## **ADDENDUM NO. 2**

DATE: **March 30, 2016**  
OWNER: **City of Stockbridge**  
PROJECT: **Willow Springs Pump Station Rehabilitation**  
C & S PROJECT NO.: **S9100.004**  
ENGINEER: **Martin C. Boyd, P.E.**  
**CARTER & SLOOPE, INC.**  
**P.O. Box 534**  
**Watkinsville, Georgia 30677**  
**Telephone: 706-769-4119 Fax: 706-769-4546**  
**Email: mboyd@cartersloope.com**

## II. CONTRACT DRAWINGS

DSGN:	MCB
DRWN:	HCC/ZWT
SCALE:	AS SHOWN
DWG. NAME:	PUMP STATION
PROJ. NO.:	S9100.004
DATE:	SHEET NO.:
DECEMBER 2015	5
	OF 11 SHEETS

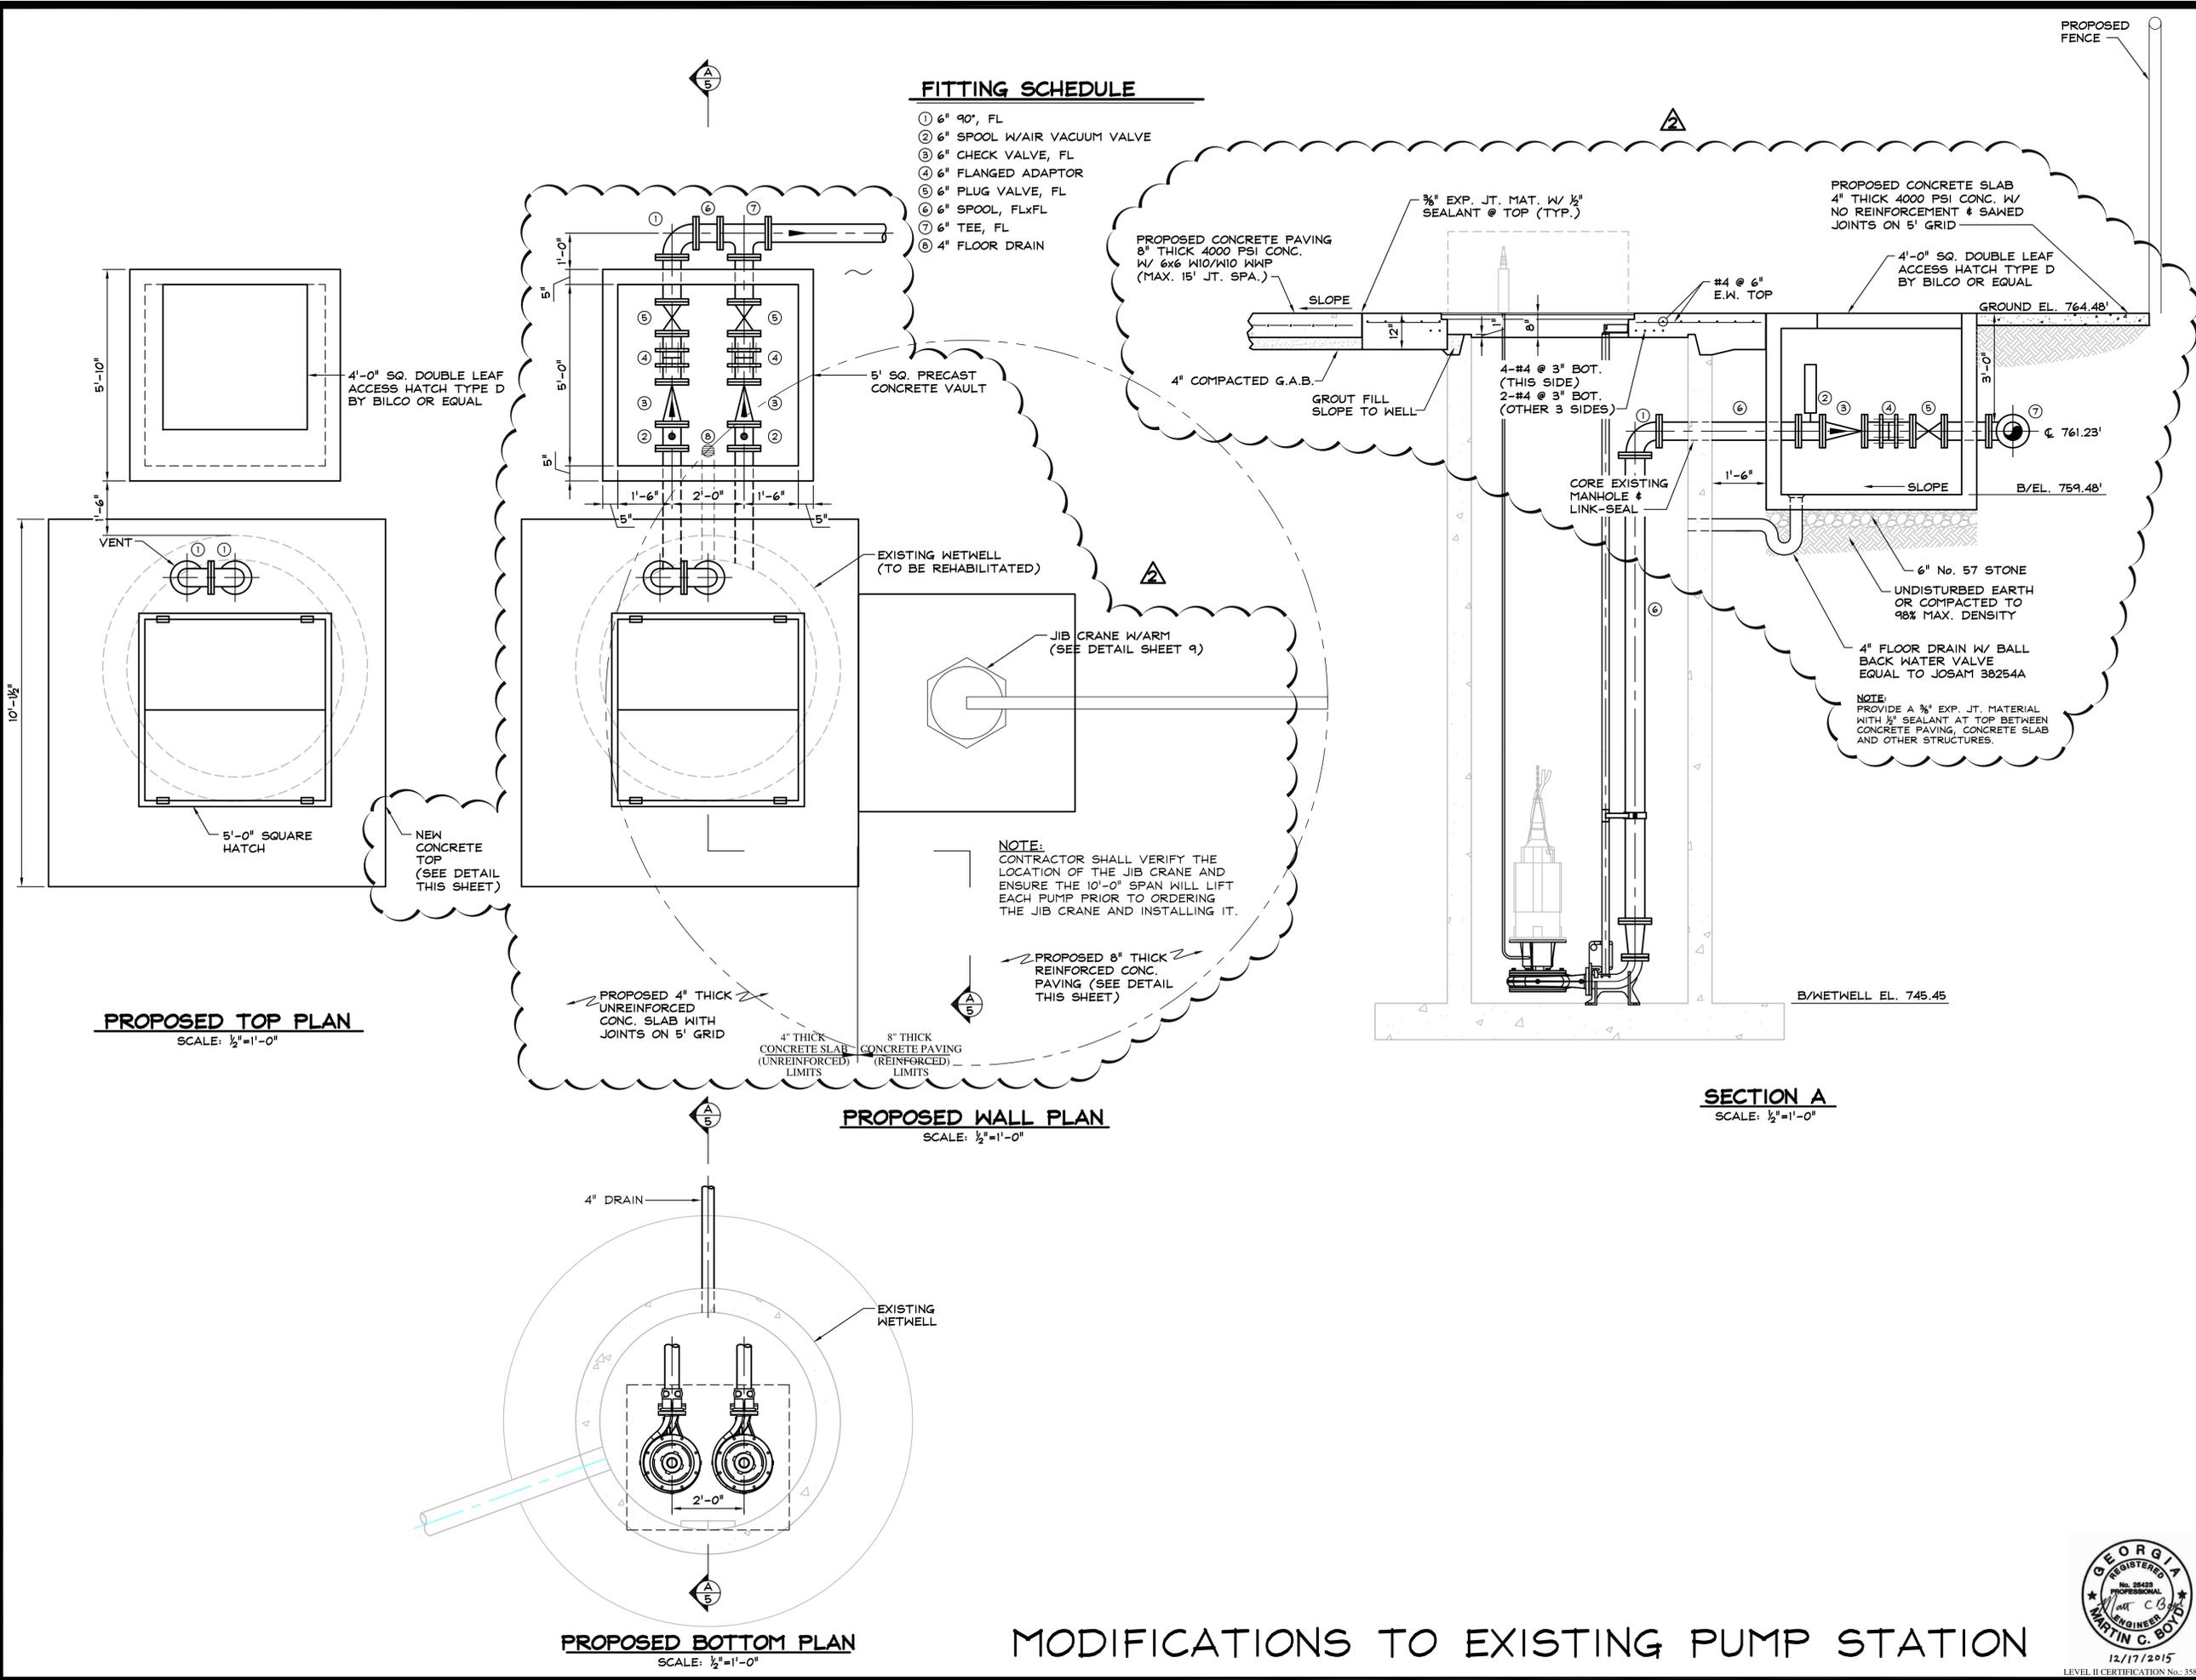
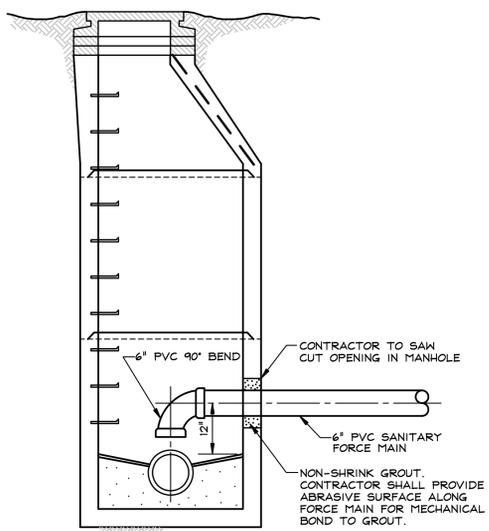
NOTE: CONTRACTOR SHALL VERIFY THE LOCATION OF THE JIB CRANE AND ENSURE THE 10'-0" SPAN WILL LIFT EACH PUMP PRIOR TO ORDERING THE JIB CRANE AND INSTALLING IT.

**TYPICAL CONCRETE PAVING**  
N.T.S.

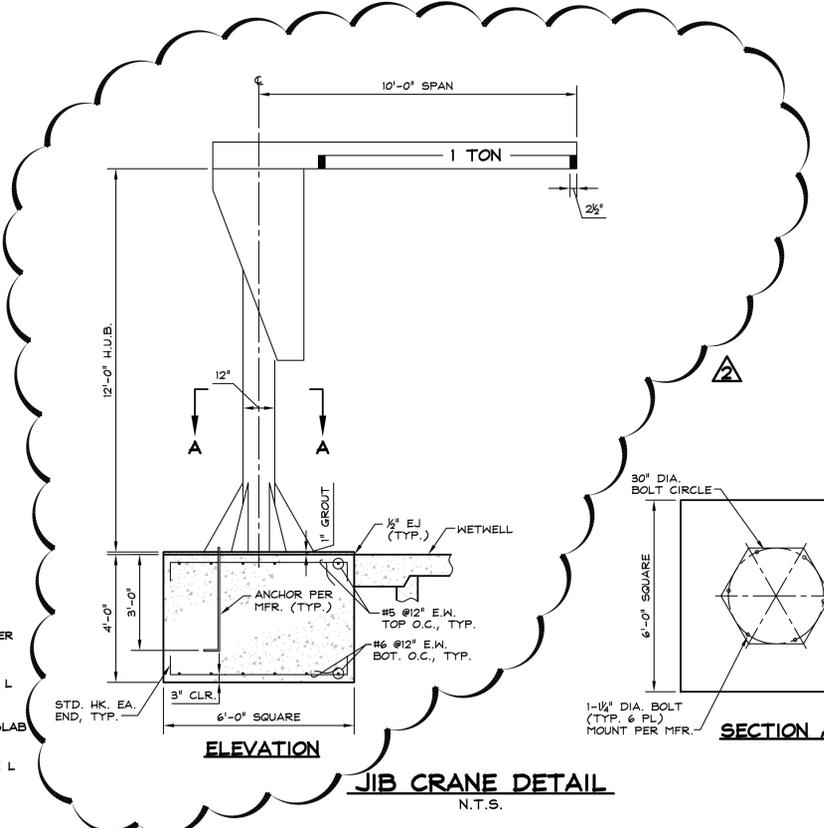
3. For installing 8" thick 4,000 psi concrete drive per the detail on Sheet 9 in lieu of asphalt paving, Add or Deduct (circle one) the amount of:
